MARK	DATE	DESCRIPTIONS	BY	CH'D	CCO#
		REVISIONS			
2	01/31/07	WEST DEVIATION SADDLE GEOMETRY	AS	JD	15
1	07/21/06	W2 CAP BEAM ISD	JD	NV	23

SAN FRANCISCO OAKLAND BAY BRIDGE
EAST SPAN SEISMIC SAFETY PROJECT
SELF-ANCHORED SUSPENSION BRIDGE
(SUPERSTRUCTURE & TOWER)

W2 CAP BEAM DIMENSION DETAILS NO.6

FILE => I:\bb\04-0120I\sas\contract plans and cco\cco\in progress\cco#15\decap05.dgn

WEST CABLE ANCHORAGE LAYOUT NO. 3

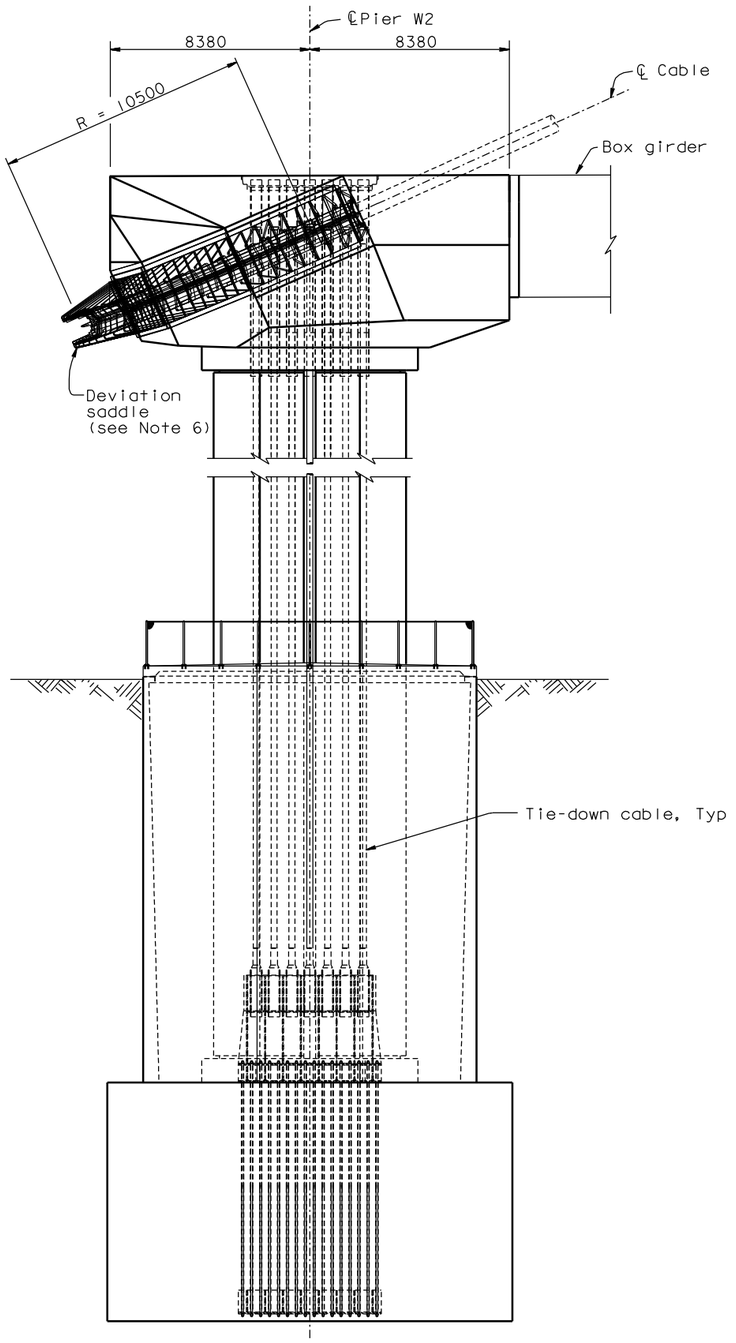
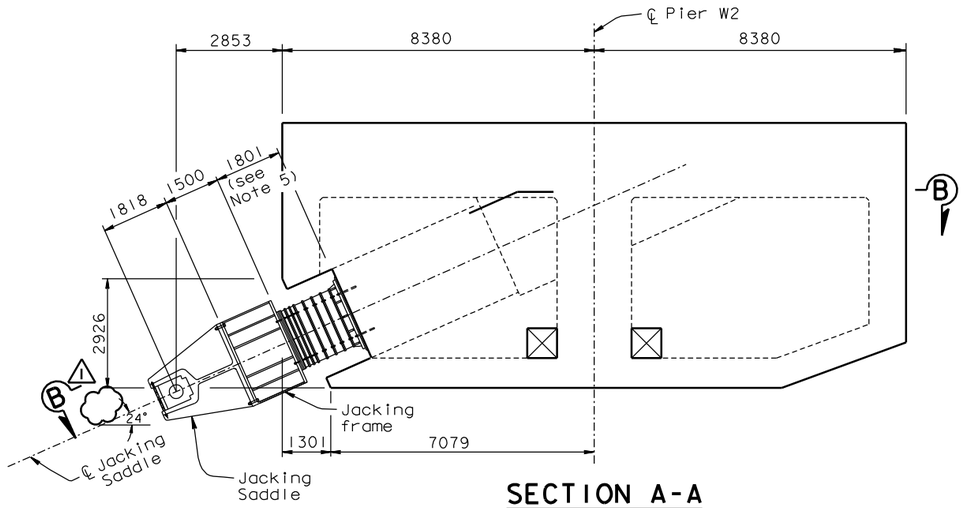
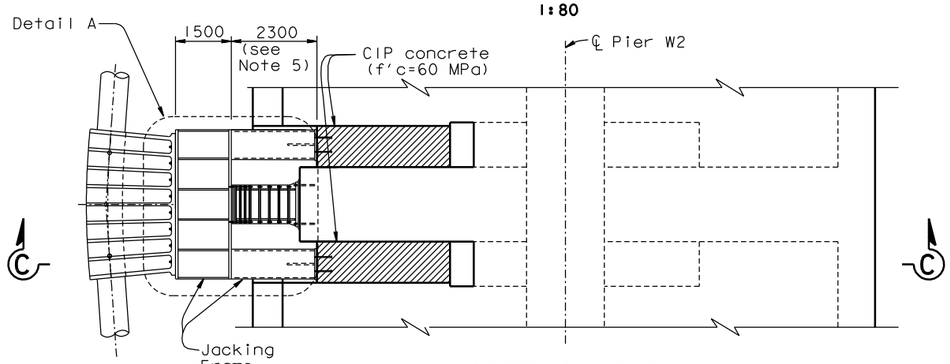
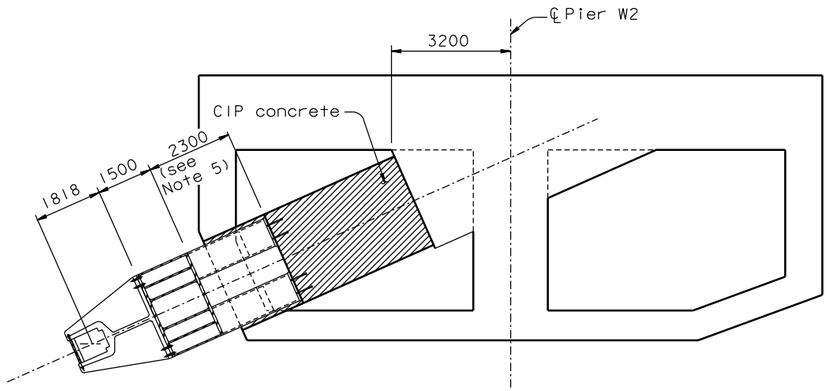
3 **REVISED PER ADDENDUM NO. 3 DATED NOVEMBER 7, 2005**

MARK	DATE	DESCRIPTIONS REVISIONS	BY	CH'D	CCO#
1	01/31/07	WEST DEVIATION SADDLE GEOMETRY	AS	JD	15

SUSPENSION CABLE LAYOUT NO. 3

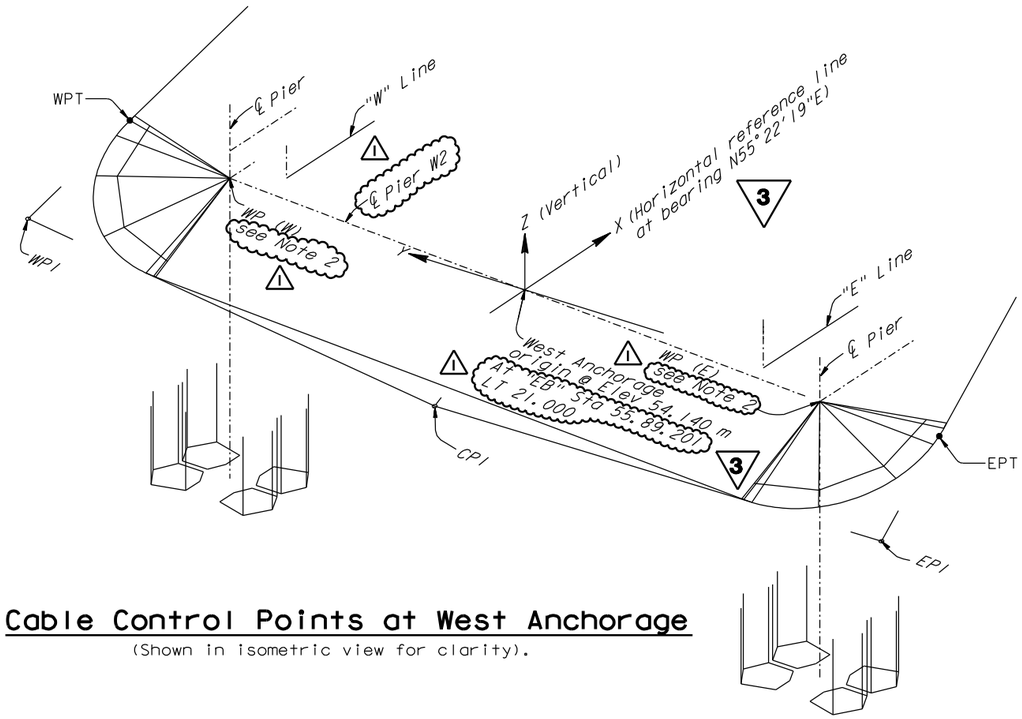
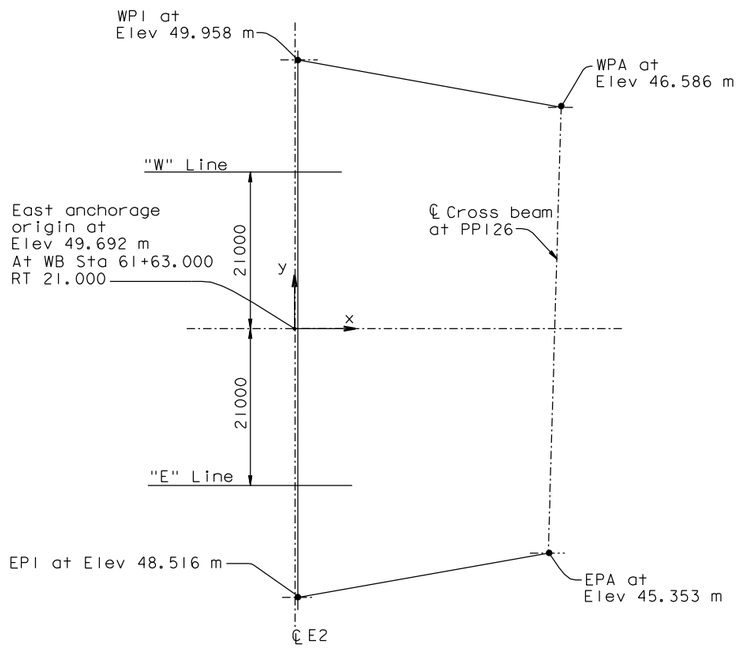
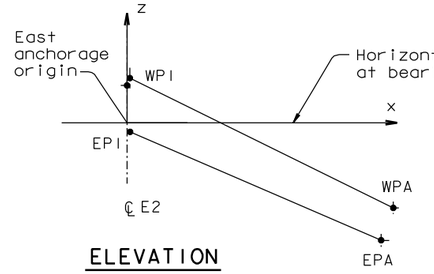
MARK	DATE	DESCRIPTIONS	BY	CH'D	CCO#
		REVISIONS			
1	01/31/07	WEST DEVIATION SADDLE GEOMETRY	AS	MN	15

3 **REVISED PER ADDENDUM NO. 3 DATED NOVEMBER 7, 2005**

PLAN VIEW (In the plan of the Deviation saddle)
1:40
(South Deviation saddle shown
North Deviation saddle opposite hand, except as noted)

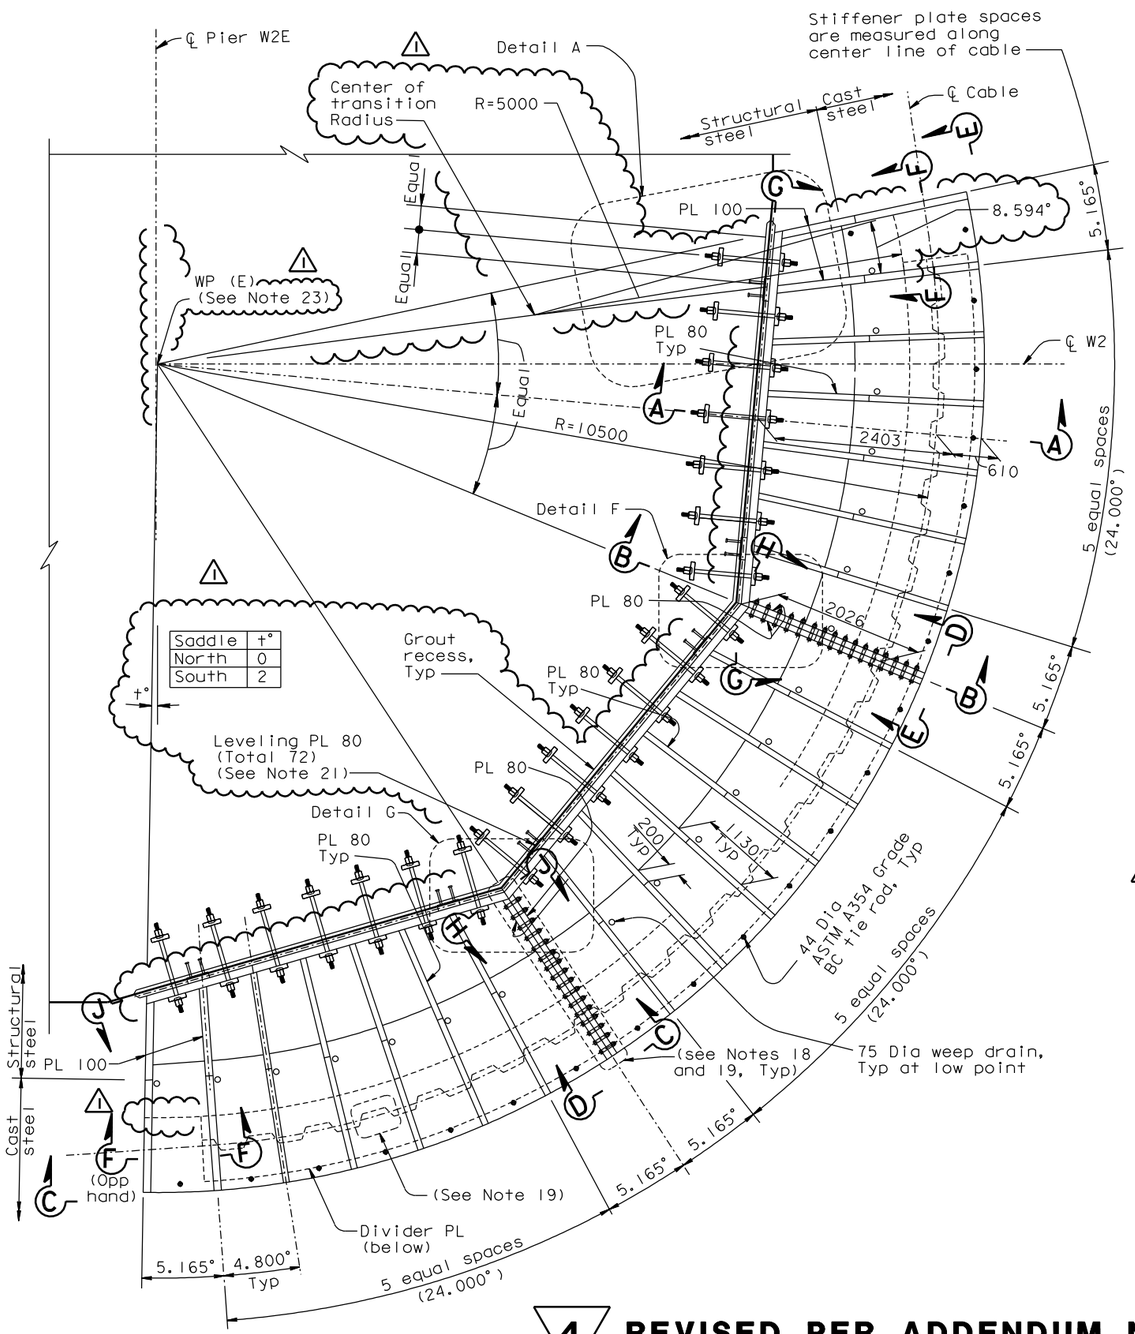
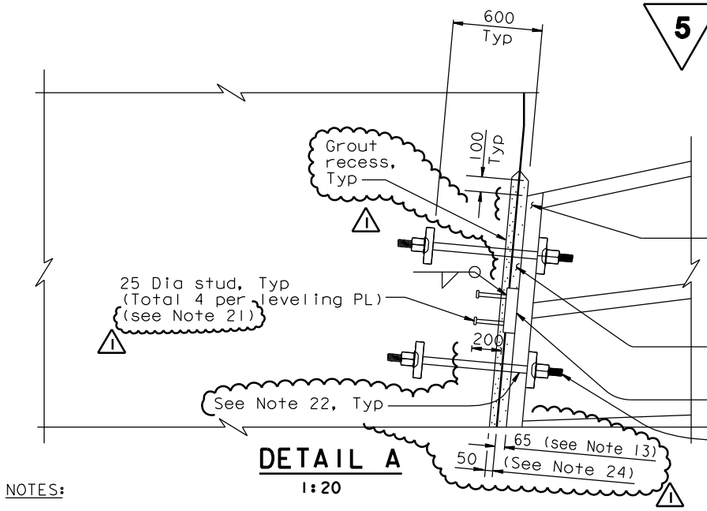
24. West deviation saddle grout recess shall be parallel to concrete faces of cap beam.

4 REVISED PER ADDENDUM NO. 4 DATED DECEMBER 9, 2005

5 REVISED PER ADDENDUM NO. 5 DATED DECEMBER 21, 2005

5 **SECTION B-B** (Anchor rods not shown for clarity)
1:20

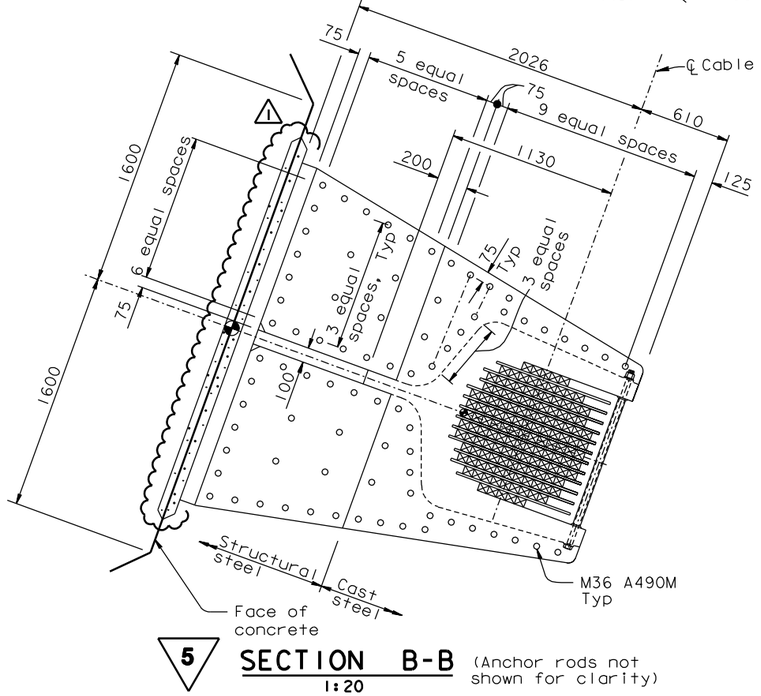
5 **REVISED PER ADDENDUM NO. 5 DATED DECEMBER 21, 2005**

4 **REVISED PER ADDENDUM NO. 4 DATED DECEMBER 9, 2005**

5 **SECTION C-C**
1:25

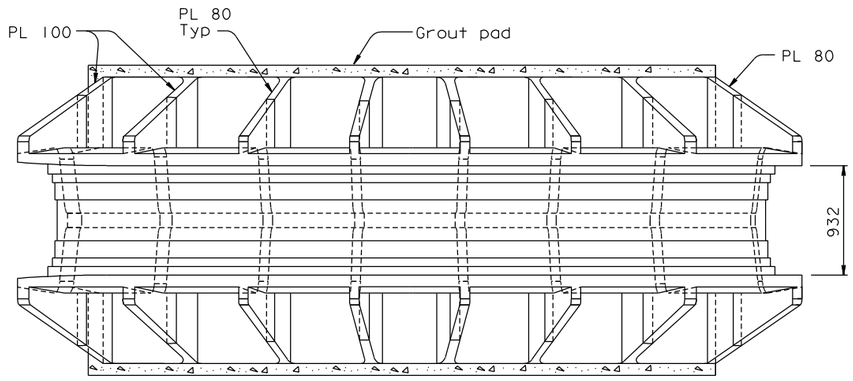
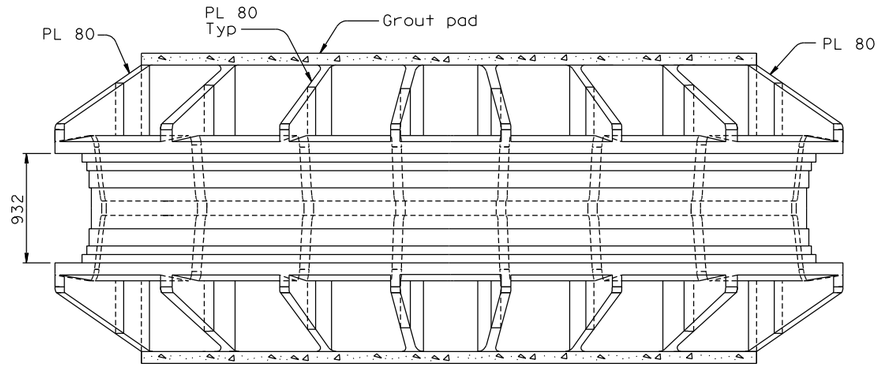
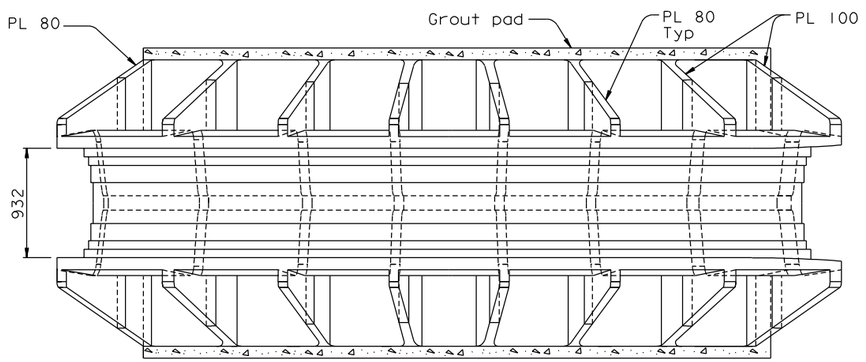
5 **REVISED PER ADDENDUM NO. 5 DATED DECEMBER 21, 2005**

5 DETAIL A
1:5

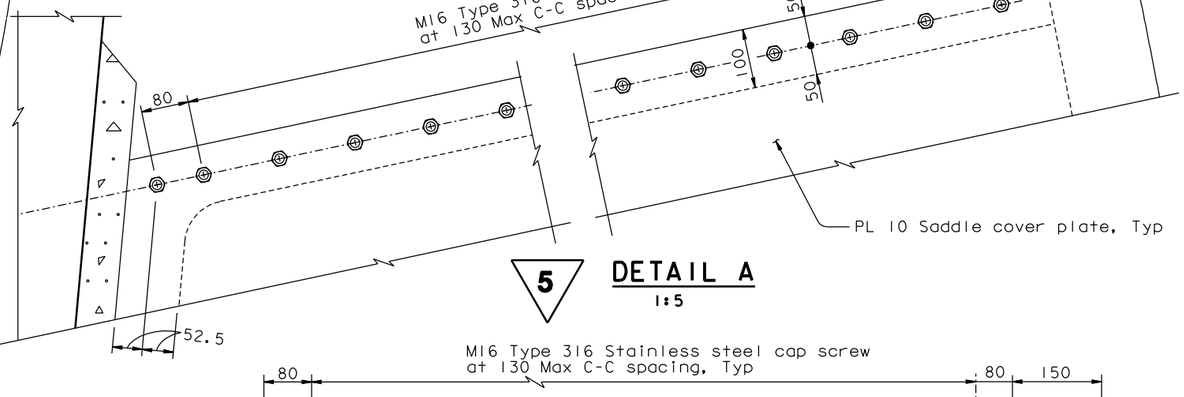
5 REVISED PER ADDENDUM NO. 5 DATED DECEMBER 21, 2005

⚠1 SECTION A-A
1:50

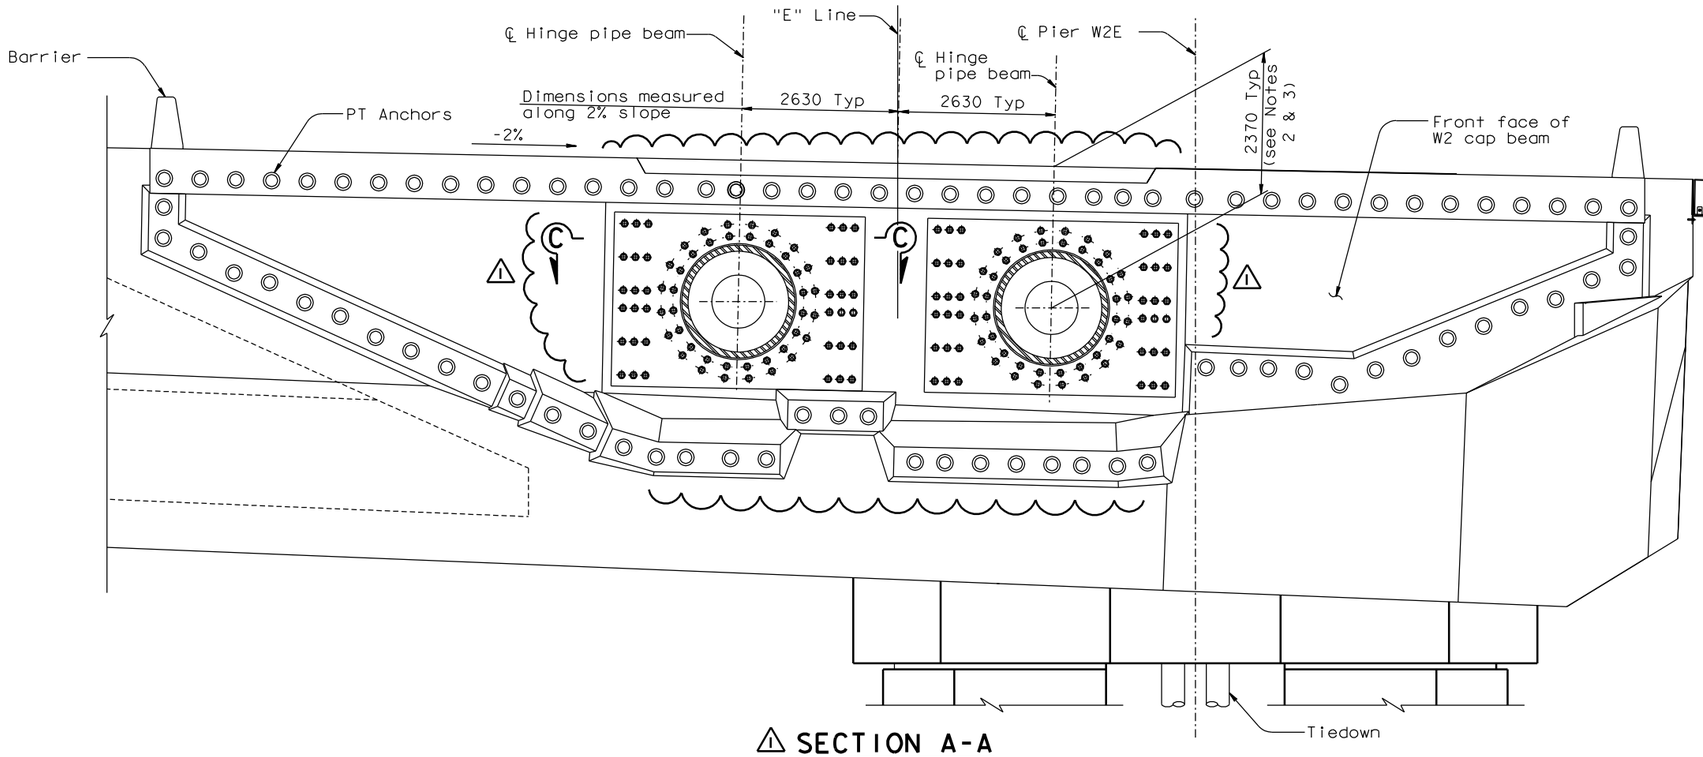
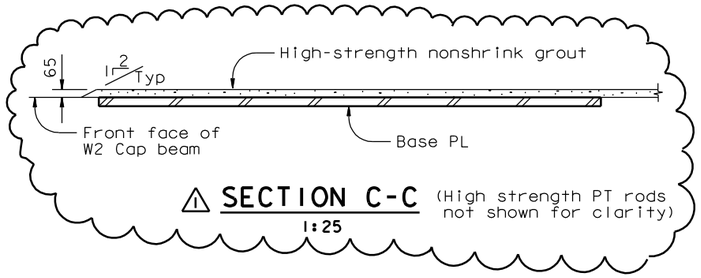
MARK	DATE	REVISIONS	BY	CH'D	CCO#
2	01/31/07	HINGE K PIPE BEAM BLOCKOUTS	JD	NV	15
1	07/21/06	W2 CAP BEAM ISD	JD	NV	23

5 SECTION G-G (Pipe beam anchorage) (see Note 3)

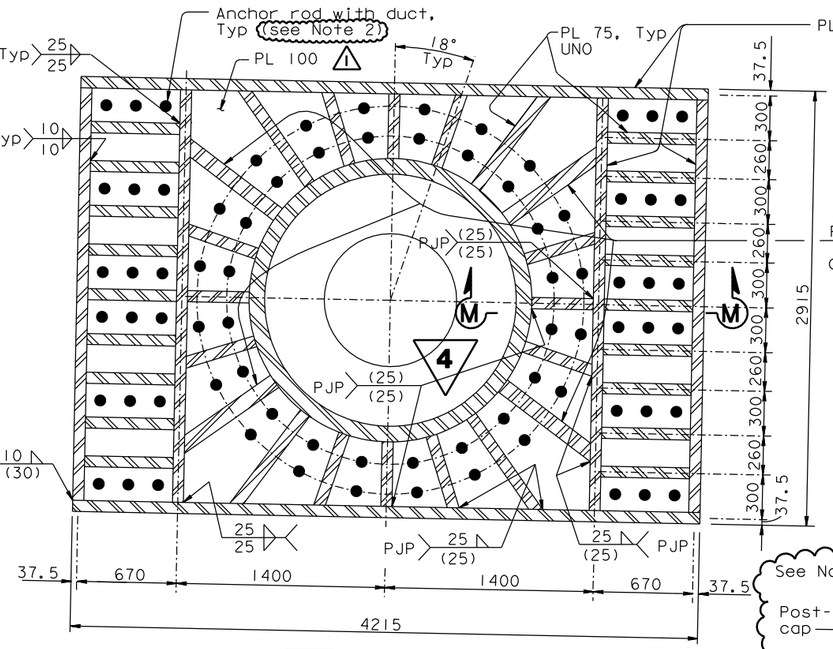
5 REVISED PER ADDENDUM NO. 5 DATED DECEMBER 21, 2005

Step 4

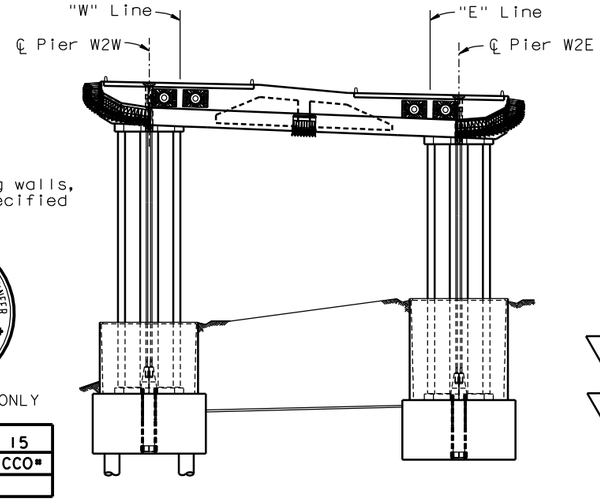
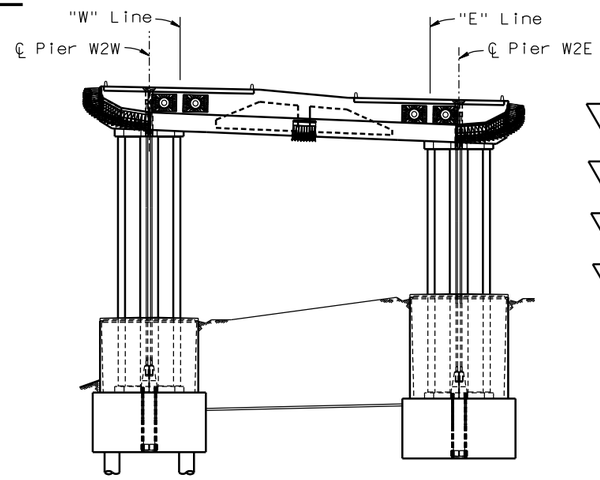
3 **REVISED PER ADDENDUM NO. 3 DATED NOVEMBER 7, 2005**

3 1. Install tie-down stay cables and stress specified design force.

3 2. Install Jacking Saddle.

3 1. Secure main span deck end segment and pour main span deck closure joint at cap beam.
